CALL NO. 200
CONTRACT ID NO.
131212 Addendum # 2

Subject: Marshall Trigg County, 121GR13D012 - NHPP 0801 (098)
Letting December 20, 2013

- (1) Revised - Plan Sheets - R2, S2, S134, S183, S184A, S184B, S187, S192, S194, S206, S207, S207A, S207B, S208, S208A, S208B, S209, S209A, S210, S211, S212, S213, S216, S217, S260, S261, S274
- (2) Revised - Cover Page - PAGE 1 of 403
- (3) Revised - Completion Dates - Page 4 of 403
- (4) Revised - Multiple Notes - Various Pages
- (5) Revised - Bid Items - Page 397-403 of 403
- (6) Delete - Pages 27thru44, 216thru233, 207thru215, 234thru238 of 403

COMBINATION RAIL PLAN

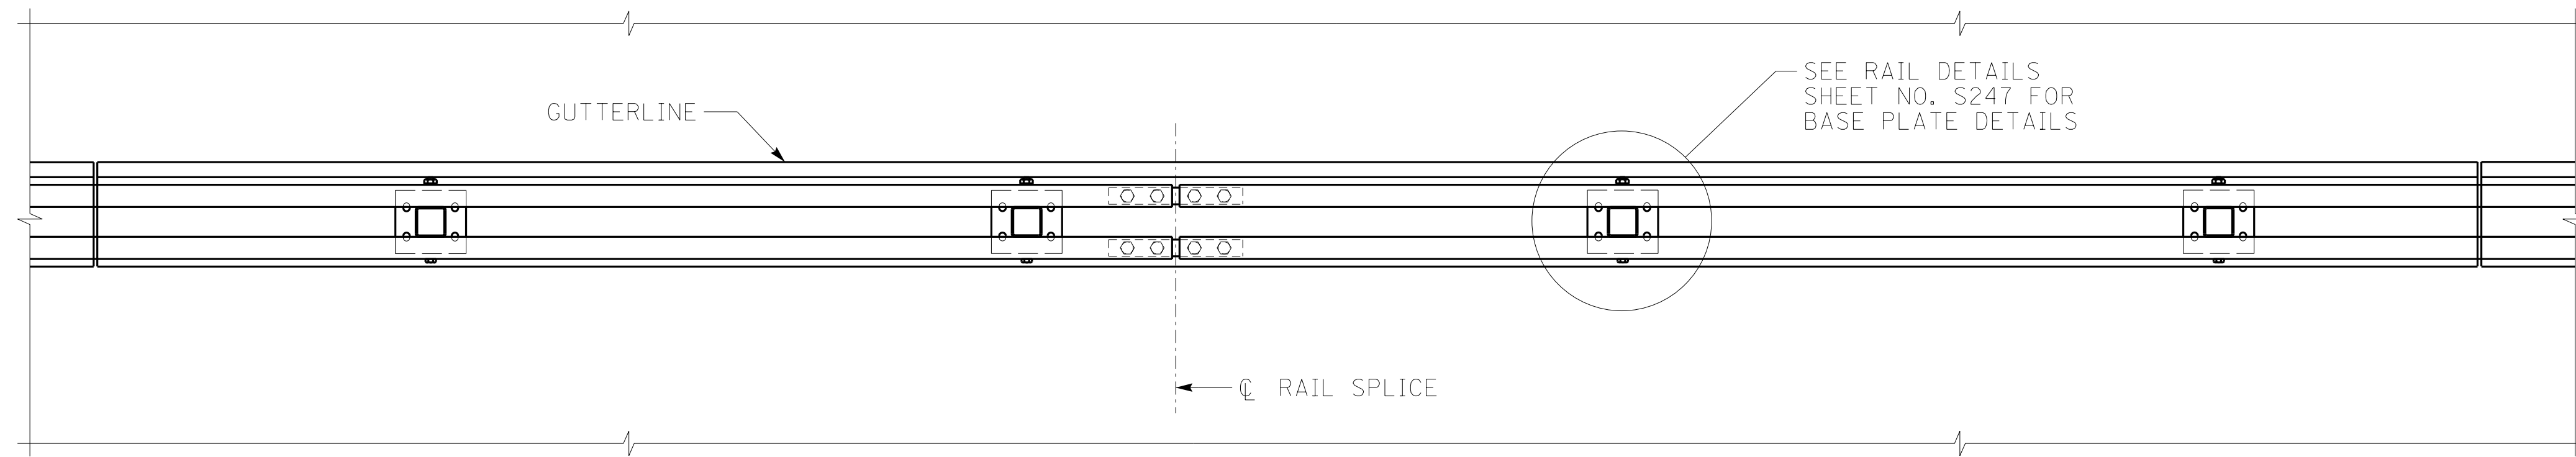
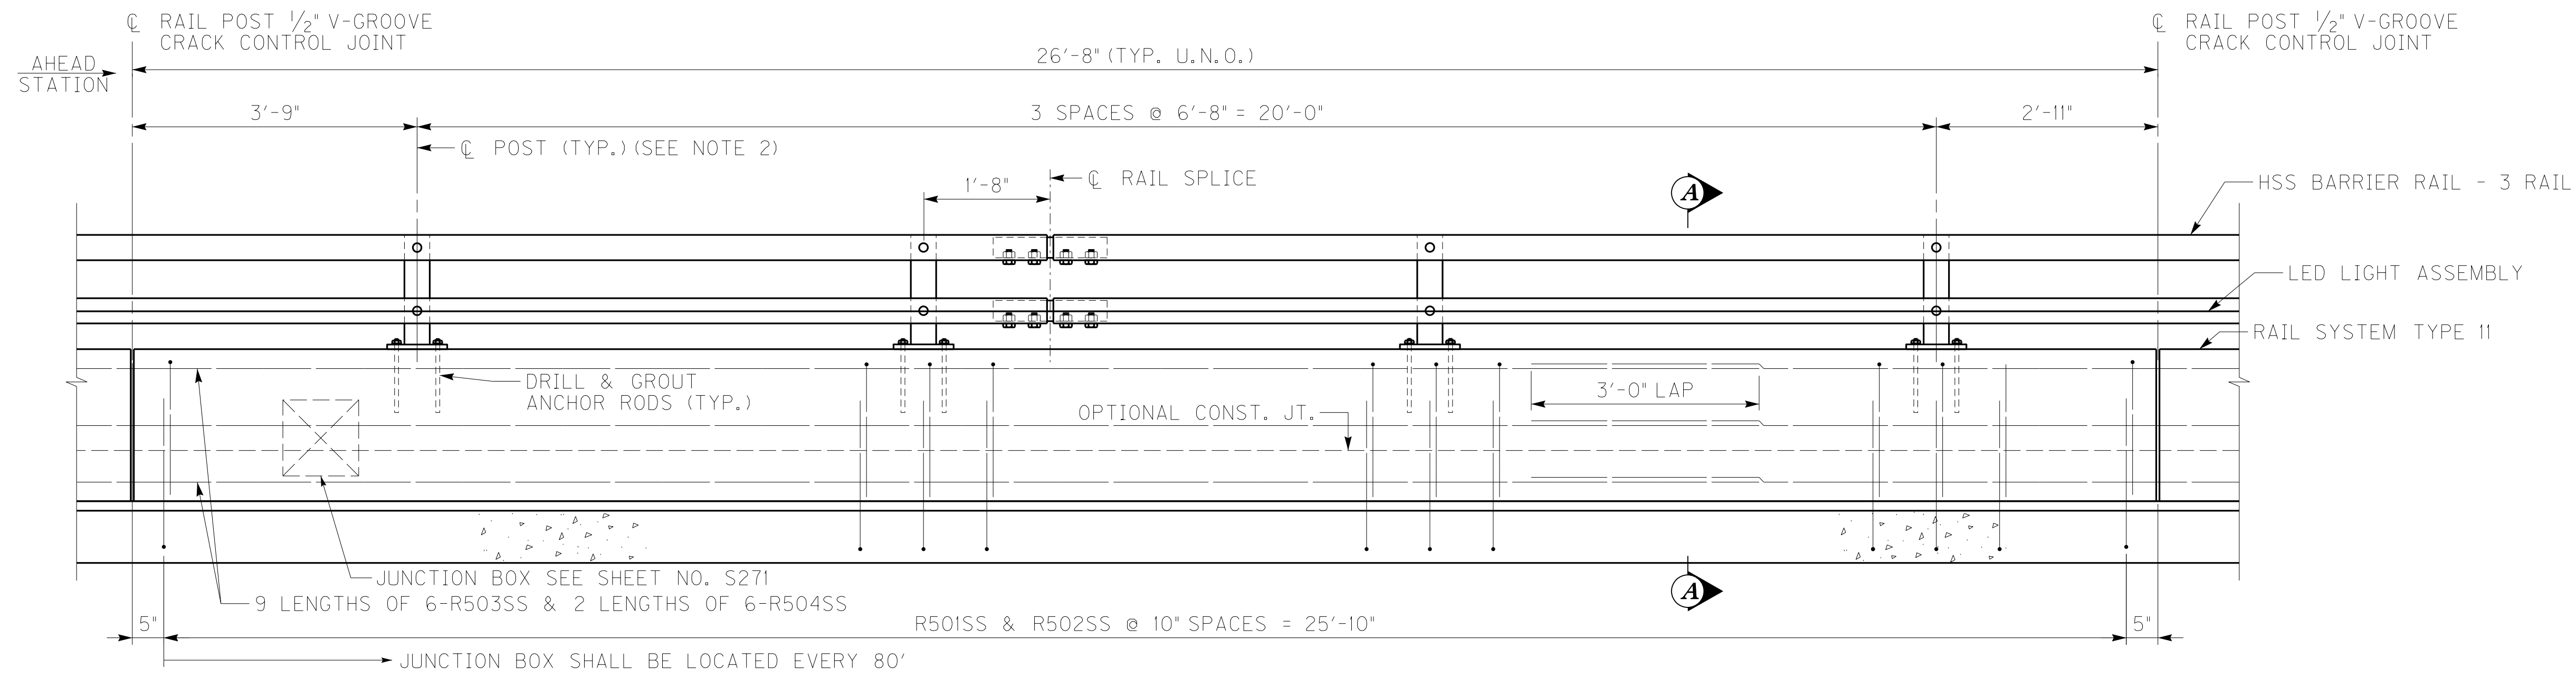
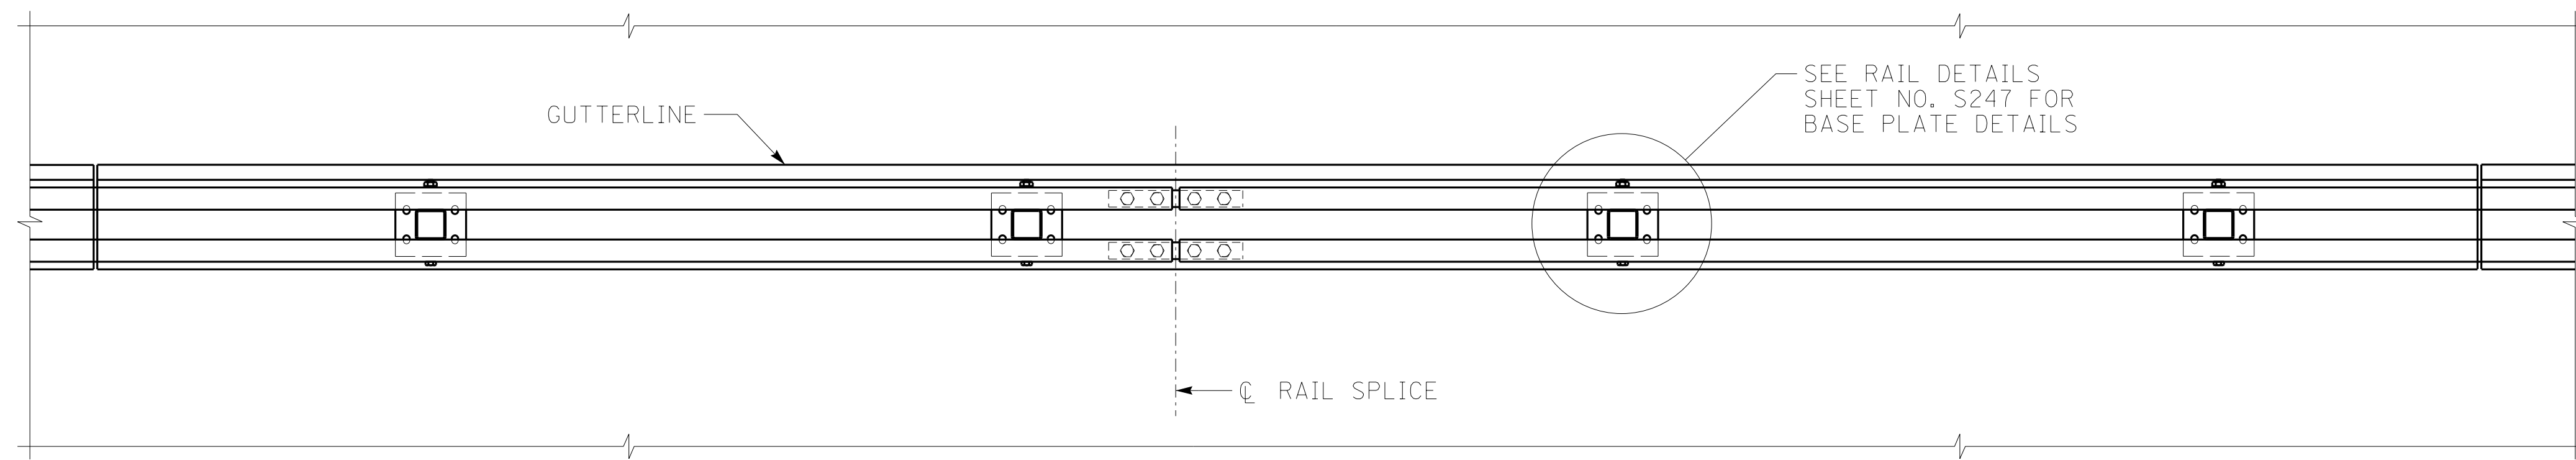
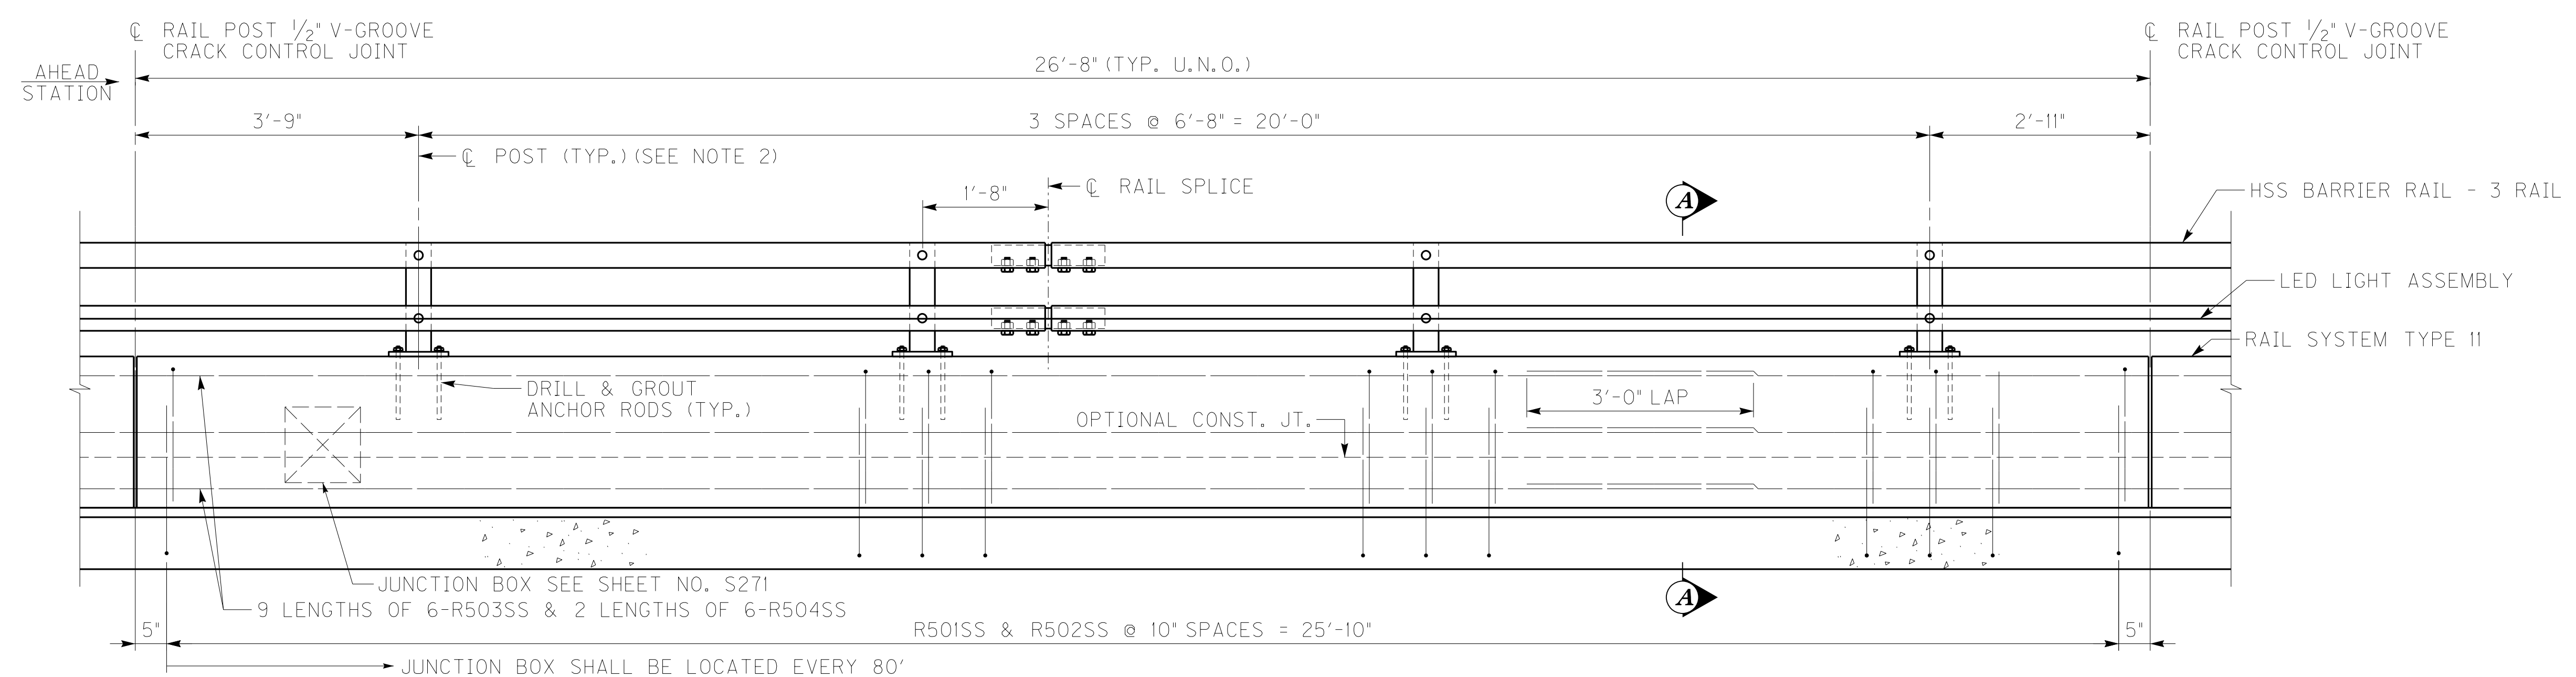
REVISION		DATE
△ REVISED BILL OF REINFORCEMENT		11/25/13
DATE: NOVEMBER 15, 2013	CHECKED BY	
DESIGNED BY: ACK	MJD	
DETAILED BY: MJD	ACK	
Commonwealth of Kentucky DEPARTMENT OF HIGHWAYS		
COUNTY MARSHALL / TRIGG		
ROUTE US68	CROSSING KENTUCKY LAKE	
SLAB BILL OF REINFORCEMENT		
ITEM NUMBER	PREPARED BY	SHEET NO.
01-180.70	Baker	S217
	MICHAEL BAKER JR. INC. 9750 ORMSBY STATION ROAD SUITE 210 LOUISVILLE, KY 40223	DRAWING NO. 24686
